**Re: 2013 Amended General Rate Application of Newfoundland and Labrador Hydro**

**UPDATED PRE-FILED TESTIMONY OF  
P. BOWMAN AND H. NAJMIDINOV  
IN REGARD TO NEWFOUNDLAND & LABRADOR HYDRO  
2013 AMENDED GENERAL RATE APPLICATION  
(Re: April 28, 2014 Pre-Filed Testimony of P. Bowman and H. Najmidinov)**

Island Industrial Customers Group

InterGroup Consultants Ltd.

1 **Figure 4-1: Holyrood Gross Fuel Conversion Rate adjusted to 2015 Test Year Heat Content vs**  
 2 **Average Gross Unit Loading 2009-2014<sup>40</sup>**

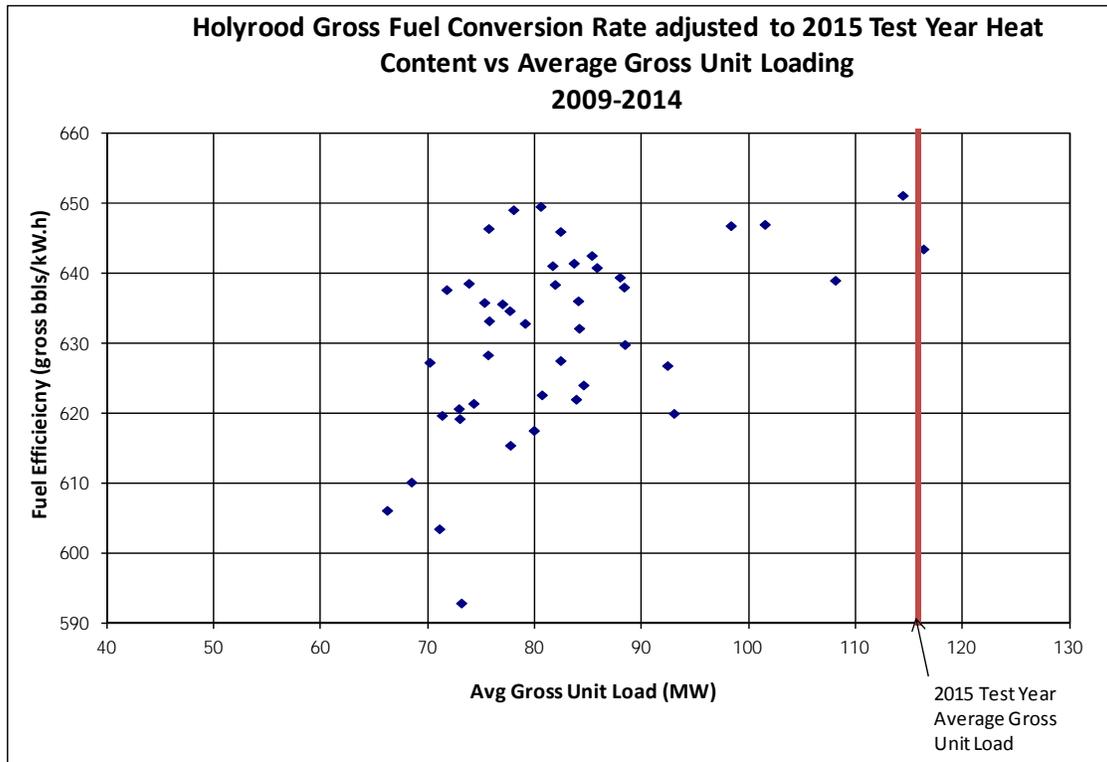
4 Hydro notes that the conversion factor forecast at 607 kW.h/bbl net is linked to a gross efficiency of 650  
5 kW.h/bbl at the gross unit level, based on a regression analysis using June 2009 to May 2014 actuals. This  
6 reflects a regression based on two variables: (1) unit average monthly gross loading (i.e. how hard the  
7 units were being run), and (2) fuel heat content. The calculations are provided in response to IC-NLH-160.

19 Third, the regression is calculated on the basis of fuel required as compared to unit loading. This gives a  
20 very high correlation (effectively the r-squared value) as, unsurprisingly, higher loading required more fuel.  
21 Fuel efficiency is only a very small component of the total fuel required, and is almost lost in this high  
22 r-squared value<sup>39</sup>. The proper assessment would be to complete a regression of load against the variable  
23 of concern (gross efficiency) which is a derivative of the total fuel used. When this adjustment is made, it  
24 become far clearer that Hydro's data in fact does not represent a strong correlation.

25 The resulting comparison of efficiency, with the input fuel normalized to the same heat content expected  
26 as part to the current GRA, is shown in Figure 4-1 below.

Figure 4-2: Holyrood Station Service Factor vs Net Production<sup>48</sup>

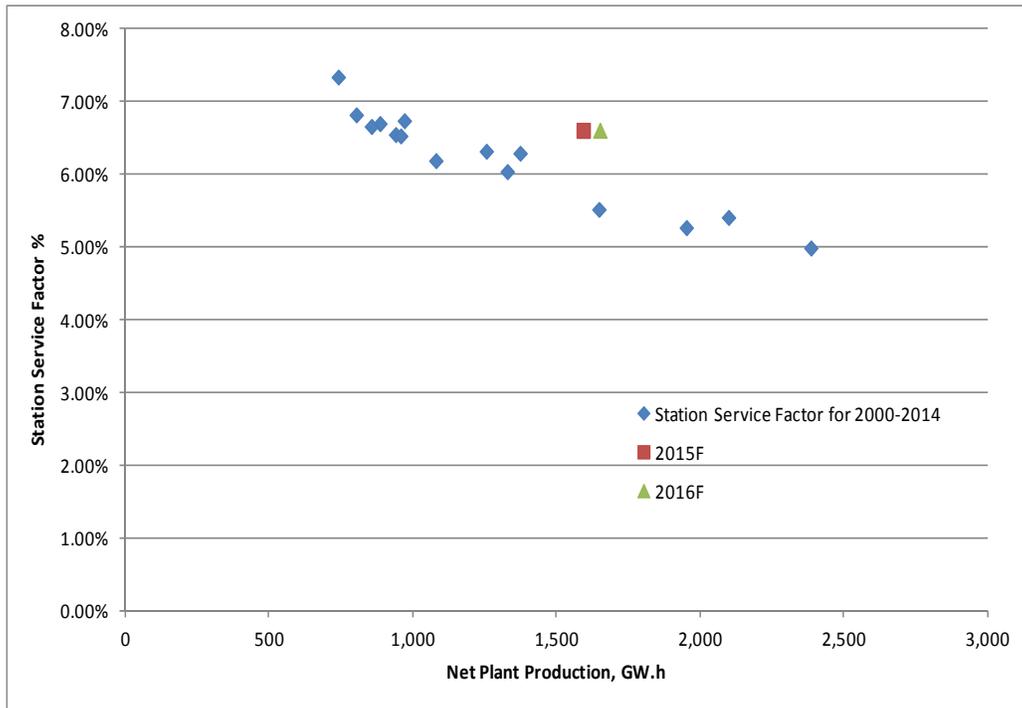
11 The response to IC-NLH-161 shows the impact of varying this percentage from 5% up to 6.25%, indicating  
12 as much as 10 kW.h/bbl (43,000 bbls<sup>45</sup> or \$2.8 million in Test Year Revenue Requirement<sup>46</sup>) turns on this  
13 estimate. Hydro also uses this same 6.61% as a forced value for analyzing the regression of previous year  
14 data, including the 5 year analysis used for the GRA purposes (NP-NLH-069 Rev. 1)<sup>47</sup>, a 10 year forecast  
15 (NP-NLH-337) and a case from 2001-2005 (NP-NLH-334).

16 Looking at past data, it is apparent that 6.61% is not representative of expectations when Holyrood loads  
17 are as high as forecast for 2015 or 2016 as provided in Figure 4-2 below.

3 The results in Figure 4-2 indicate that if the 2015 values solely followed past trends, the station service  
 4 should be on the order of 5.85% (36 kW.h/bbl used in station service, an improvement of 7 kW.h/bbl over  
 5 the proposed GRA level which is the basis for the overall conversion factor of 607 kW.h/bbl net output<sup>49</sup>).  
 6 However even though this value is below that proposed by Hydro, this value would only be reasonable if  
 7 improvements had not been undertaken to Holyrood in the period since 2000. This is not the case.
